JOB NO. _____
CLARK, NEXSEN & OWEN
ARCHITECTS & ENGINEERS
COMPUTATIONS SHEET

REVISIONS IN SERVICE TO
GUGG ENHEIMER HOSPITAL
PANEL "MP"

EXISTING ROOM 7
SCALE: 1/2" = 1'-0"

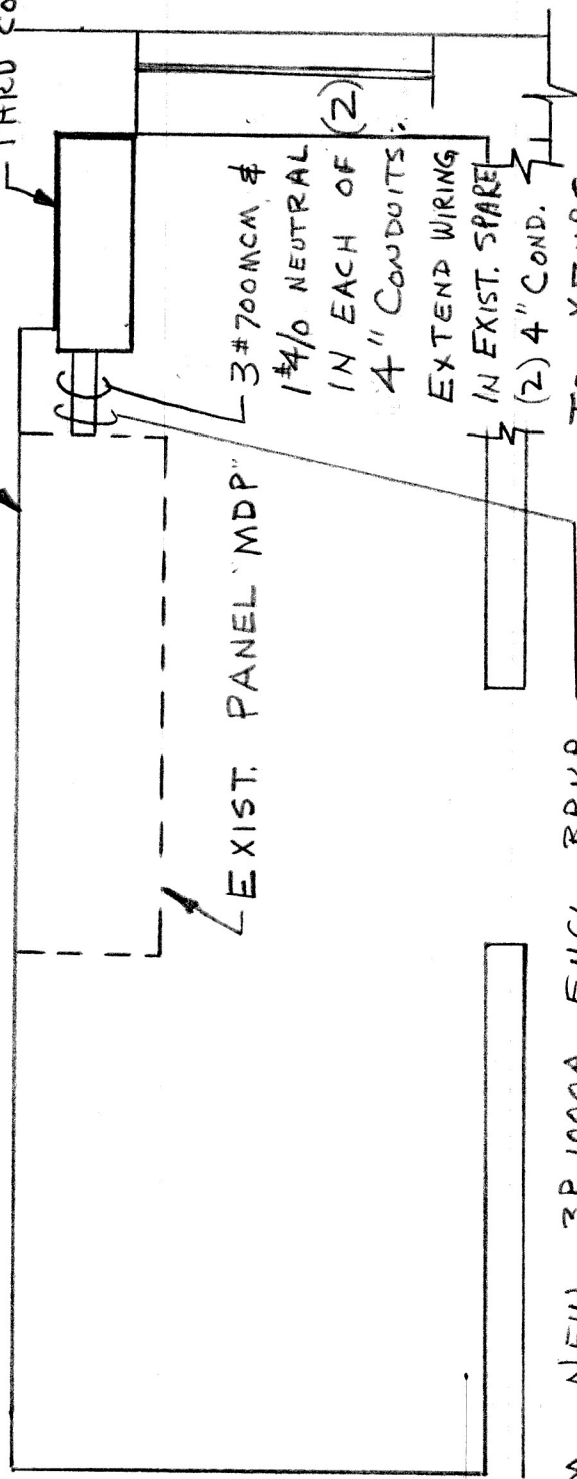
GENERAL ELECTRIC
TYPE TMK (1200A
FRAME), OR EQUAL
NEW 3P, 1000A,
240V, ENCL. CKT.
BRKR, NEMA I
ENCL. HANDLE
THRU COVER STYLE.

DELETE ALL REFERENCES
TO NEW 3P, 600A, TYPE MA
BRKR. FOR PANEL "MDP"

TO XFMRS.
DELETE ALL REFERENCES
TO NEW 4# 250MCM IN
EACH OF (2) EXIST.
SPARE 4" C.

FROM NEW 3P, 1000A ENCL. BRKR.
PROVIDE (2) 3" CONDUITS TO EXIST
SPARE (2) 3" CONDUITS ABOVE PANEL "MDP".
PROVIDE (1) ADDITIONAL 3" CONDUIT FROM
NEW 3P, 1000A ENCL. BRKR. TO PANEL "MP"
IN ROOM 160. RUN 3# 350MCM & 1# 2/0
NEUTRAL IN EACH OF THESE (3) 3" CONDUITS
FROM NEW 3P, 1000A ENCL. BRKR TO PANEL "MP", ROOM 160.
DELETE ALL REFERENCES TO 8# 250 MCM RUN FROM
"MDP" TO "MP".
